Re: Doc Bennett Road LCID
 Permit No. 26-K

Application for Permit Renewal
Doc Bennett Road Land Clearing & Inert Debris Landfill
Permit No. 36-K

Subject: Comments on the Permit Amendment Application for a Five (5)-Year Permit Review
Doc Bennett Road Land Clearing and Inert Debris Landfill (LCIDLF)
Cumberland County, North Carolina,
Permit No. 26K-LCID-, Document ID No. (DIN) 23948

DATE:	MAY 27, 2014
CSE PROJ. #	BAR_0073
DRAWN	CHW
DESIGNED	CHW/GAR
CHECKED	GAR
PROJ. MGR.	CHW
DOC BENNETT ROAD LCID PERMIT RENEWAL	
PROJECT STATUS	
MAP UPDATE	
MAP UPDATE (MAY 2014)	
C-01

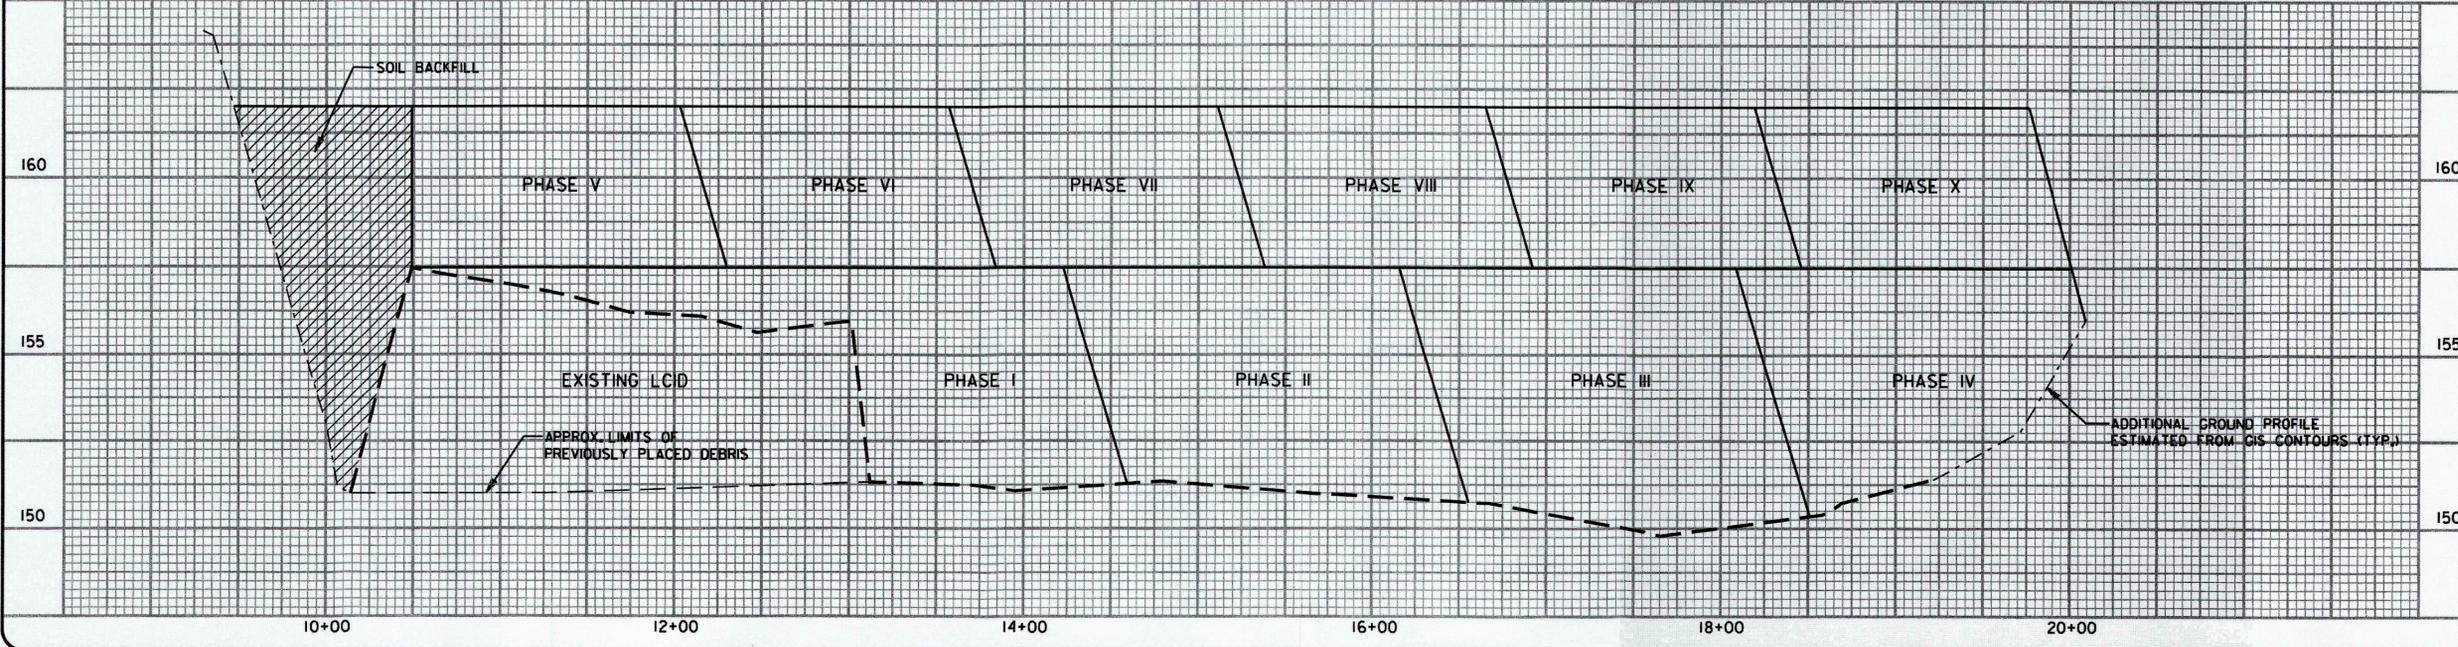
2. According to the existing permit – Permit Condition No. 2, Attachment 2 (DIN 9941) and the May 21, 2009 e-mail correspondence (DIN 7606), the LCIDLF has an approved total gross capacity of 121,991 cubic yards (CY), to be developed in fourteen (14) phases. The Map Update (May 2014) in the new permit application (DIN 23929) shows the LCIDLF will be developed in ten (10) phases without changing the final fill grades at the approximate elevation of 162 feet above mean seal level and the waste footprint of approximately 16.1 acres. Because the new phased landfill developments are proposed in this permit application, please provide the required information in the following table, which will be incorporated into the new permit:

The sum of the 10-phased volumes of the landfill is 108,221 CY, not 121,898 CY as shown in the April 9, 2015 response letter (DIN 24137). There is a shortfall of 13,677 CY. Since the drawing C-01 - Project Status, Map Update, May 2014 (DIN 23929), prepared by Call Sign Engineers, shown "Existing LCID, Approximate Limits Of Previously Placed Debris" in the stations 10+15 to 13+10 outside the proposed 10-phased development, I questioned if the above-referenced volume difference of 13,677 CY is the "previously placed waste volume."

After reviewing the 04/09/2015 responses, I found out the total capacity of the landfill is about 108,221 cubic yards (CY), not the proposed 121,898 CY. Could you please verify the volume of each phase? Or the difference of 13,677 CY is the in-place waste volume in Phases I. Please clarify. Thank you for the help.

Landfill Phases	Acreage (AC) ^a	Capacity (CY) ^b	Status ^c
I	3.8	10,694	Constructed & Active
II	1.7	11,917	Permitted
III	1.7	13,036	Permitted
IV	1.8	7,259	Permitted
V	0.0	12,400	Permitted
VI	Vertical Expansion	12,917	Permitted
VII	Vertical Expansion	12,917	Permitted
VIII	Vertical Expansion	13,692	Permitted
IX	Vertical Expansion	14,467	Permitted
X	Vertical Expansion	12,600	Permitted
Total	9.0	121,898

- a. Please note that the total waste footprint will be approximately 9 acres, not the 16.1 acres referenced. In reviewing the original permit drawings it appears the 16.1 acres was a drainage area for the sediment basin and not the actual waste area. The above figures should be more accurate.
- b. Waste capacities for each phase are noted above.
- c. As noted in the table, Phase I is active and currently receiving waste material. The remaining phases will receive waste as the previous phase is filled. It is not known at this time how quickly these phases will be completed but all phases should be included in this 5-year renewal.

It is still not clear to us where you derived your figure of 108,221 CY. However, the figures provided to you previously were based on average lengths, widths and depths and did not account for side slopes, end slopes, cover material, etc. We have since gone back to our drawing and used more accurate dimensions to come up with the following areas and volumes for each phase. You will note that we have also addressed the volume shown as "Existing LCID, Approximate Limits of Previously Placed Debris". Coincidentally, it is close to the 13,677 CY figure you provided but the two are not related.

Landfill Phases	Acreege (AC)	Capacity (CY)	Status
<i>Previously Completed</i>	2.8	13,200	<i>Constructed</i>
I	3.8	8,361	Current & Active
II	1.8	10,924	Permitted
III	1.8	12,033	Permitted
IV	1.9	7,259	Permitted
V	0.0	11,022	Permitted
VI	Vertical Expansion	11,481	Permitted
VII	Vertical Expansion	11,481	Permitted
VIII	Vertical Expansion	12,170	Permitted
IX	Vertical Expansion	12,859	Permitted
X	Vertical Expansion	11,200	Permitted
Total	12.2	121,992

- a. Please note that the total waste footprint will be approximately 12.2 acres, not the 16.1 acres referenced. In reviewing the original permit drawings it appears the 16.1 acres was a drainage area for the sediment basin and not the actual waste area. The above figures should be more accurate and also reflect the area for side slopes, etc..
- b. Approximate waste capacities for each phase are noted above.
- c. As noted in the table, Phase I is active and currently receiving waste material. The remaining phases will receive waste as the previous phase is filled. It is not known at this time how quickly these phases will be completed but all phases should be included in this 5-year renewal.
